Item Name: Fwd Crosstube - Mid Height 206L / L1 / L3 / L4

DART AEROSPACE LTD HAWKESBURY, ONTARIO, CANADA	
DRAWING NO. D206-667-147	REV. A SHEET 1 OF 4
TITLE CROSSTUBE ASS'Y (206L MID FWD)	SCALE NTS

DRAWING NO. D206-667-147	TITLE CROSSTUBE ASS'Y (206L MID FWD)	REV. A	DART AEROSPACE LTD ENGINEERING ORDER		D.E.O. NO. D206-667-147-A-1	SHEET NO. SHEET 1 OF 1	SCALE NTS
DRAWN <i>qp</i>	CHECKED <i>ASS</i>	MFG. APPR. <i>JB</i>	APPROVED <i>MD</i>		DE APPR. <i>TH</i>		
DATE 11.07.15	DATE 11.07.20	DATE 11.07.21	DATE 11/07/21		DATE 11.07.21

DRAWING NO. D206-667-147	TITLE CROSSTUBE ASS'Y (206L MID FWD)	REV. A	DART AEROSPACE LTD ENGINEERING ORDER	D.E.O. NO. D206-667-147-A-2	SHEET NO. SHEET 1 OF 1	SCALE NTS
DRAWN AJS	CHECKED	MFG. APPR. <i>E</i>	APPROVED <i>AD</i>	DE APPR. <i>AD</i>		
DATE 12.08.02	DATE 12.08.02	DATE 12.08.02	DATE 12.08.02	DATE 12.08.02	DATE 12.08.02

DETAIL P
BONDING STRAP INSTALLATION 2 PL

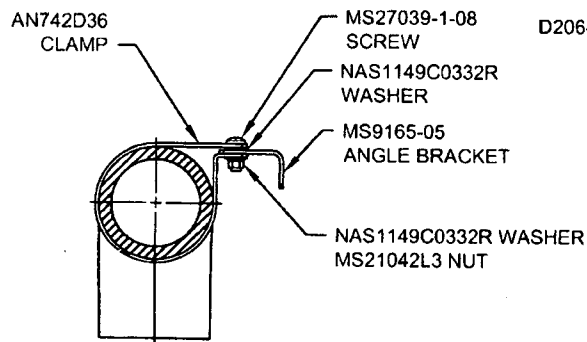
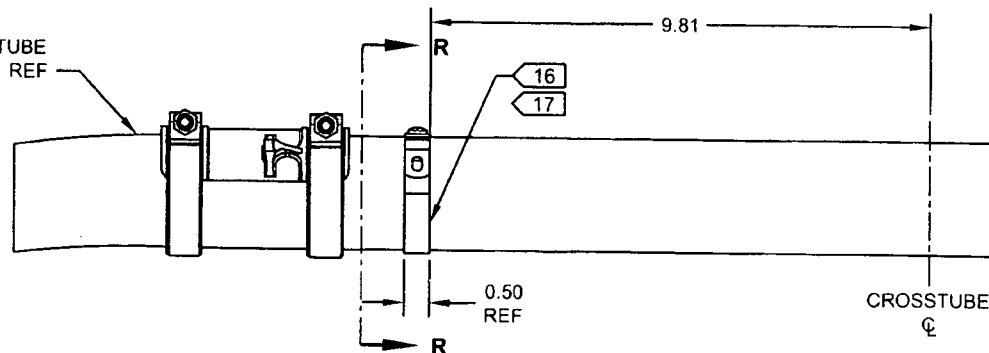
ADD ELECTRICAL GROUNDING STRAP

- 16) MASK AREA UNDER CLAMP PRIOR TO PAINTING
- 17) SEAL EDGES WHERE AN742D36 CLAMP MEETS WITH THE CROSSTUBE USING SIKAFLEX-241/-291 OR MIL-S-8802 CLASS B2 OR PROSEAL 890 SEALANT
- 18) PERFORM RESISTANCE CHECK TO ENSURE MAX RESISTANCE IS 10 MILLIOHMS
